**STATE OF CONNECTICUT  
CONNECTICUT SITING COUNCIL**

**PETITION OF CROWN CASTLE TOWERS 06-2 :  
LLC AND NEW CINGULAR WIRELESS PCS, : DOCKET NO. 546  
LLC d/b/a AT&T FOR A CERTIFICATE OF :  
ENVIRONMENTAL COMPATIBILITY AND :  
PUBLIC NEED FOR THE CONSTRUCTION, :  
MAINTENANCE, AND OPERATION OF A :  
TELECOMMUNICATIONS FACILITY AND :  
ASSOCIATED EQUIPMENT LOCATED AT 70 :  
UNIVERSAL DRIVE, NORTH HAVEN, : January 27, 2026  
CONNECTICUT :**

**RESPONSES OF JOINT APPLICANTS TO  
CONNECTICUT SITING COUNCIL PRE-HEARING INTERROGATORIES**

See map below of alternative parcels referenced above:

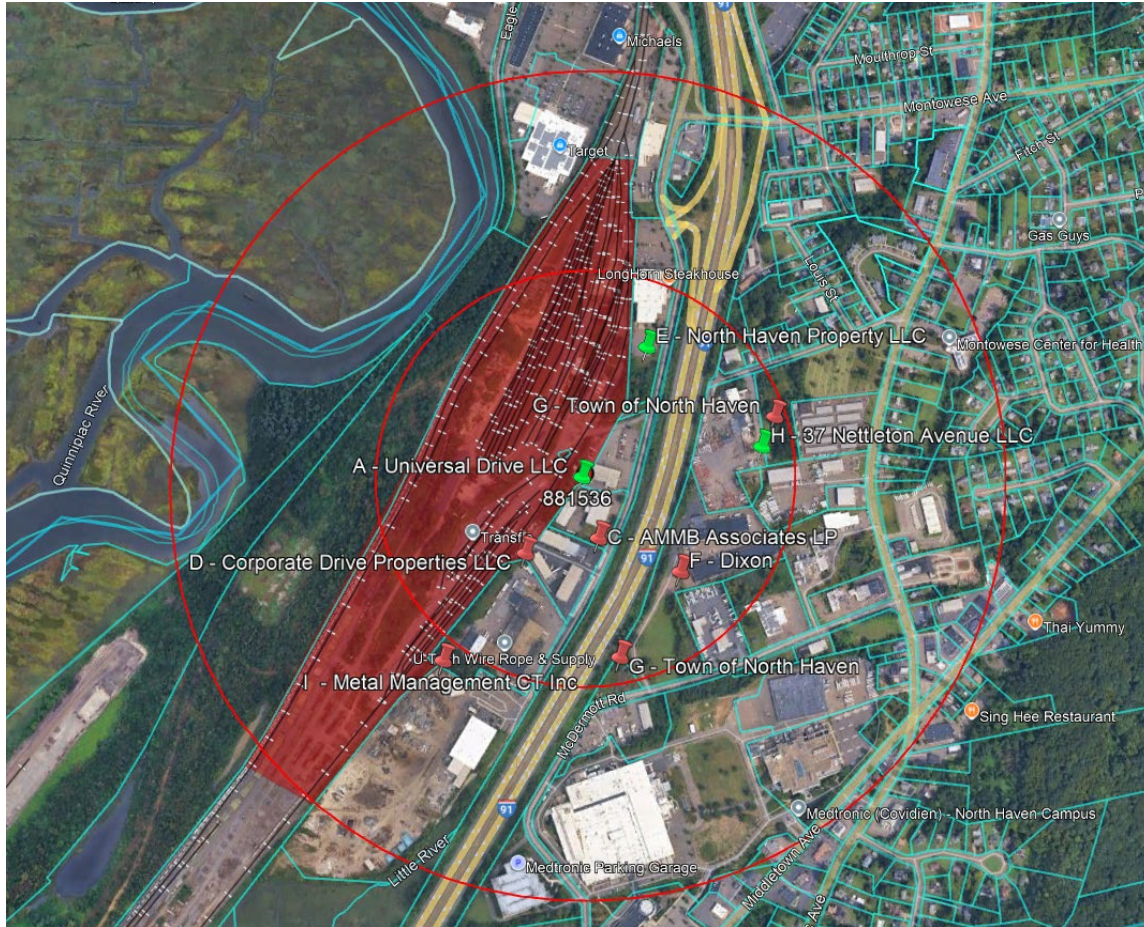
7. Referencing Application p. 12, were any other sites examined for telecommunications use? If yes, provide site locations and reasons for rejection.
  - A. Yes. As noted above, Crown established a search ring for the area and retained a site acquisition firm to review potential locations in the area. No available and feasible existing towers were identified which could support the wireless facilities of AT&T and T-Mobile. The area surrounding the existing parcel consists of industrial parcels adjacent to the railyard to the west and I 91 to the east. Crown focused on the parcels adjacent to the existing site to maintain continuity of service. All of the industrial parcels in the area are developed to some extent, and some were not conducive to a tower facility given the size of the parcel and proximity to existing structures on those parcels. The owner of the proposed site was willing to enter into an agreement, and the proposed site was only approximately 800' from the existing tower and at a similar elevation – which presented a perfect solution for a replacement tower. Additionally, the proposed location would not require significant clearing, provides ease of access, availability of utilities and minimizes visual impacts due to its location. Lastly, the existing parking on the parcel would not be negatively impacted by the tower location selected.

Below is a list of alternative parcels considered by Crown with the reasons those parcels were not selected:

**A: Universal Drive LLC - 130 Universal Drive**

The property owner initially responded with some interest but upon further outreach and contacts, became non-responsive to inquiries in March 2023.

**C - A M M B Associates LP - 150 Universal Drive**

This parcel is significantly developed, and the property owner was only interested in using the rear portion of the property which had limited space for a multi-carrier telecommunications tower and therefore was rejected.

**D - Corporate Drive Properties LLC - 222 Universal Drive**

After at least six (6) messages, the property owner’s assistant advised that the property owner was not interested.

**F- Andrew T Dixon – 78 Rebeschi Drive**

The property owner never responded to phone calls and text messages regarding the potential use of the property for a telecommunications tower.

**G - Town of North Haven – 170 McDermott Road**

The Town of North Haven indicated that there was no interest in using the parcel for a telecommunications tower, which is consistent with the letter of support from the Town submitted with this application and the Applicant’s discussions with the Town during the consultation process.
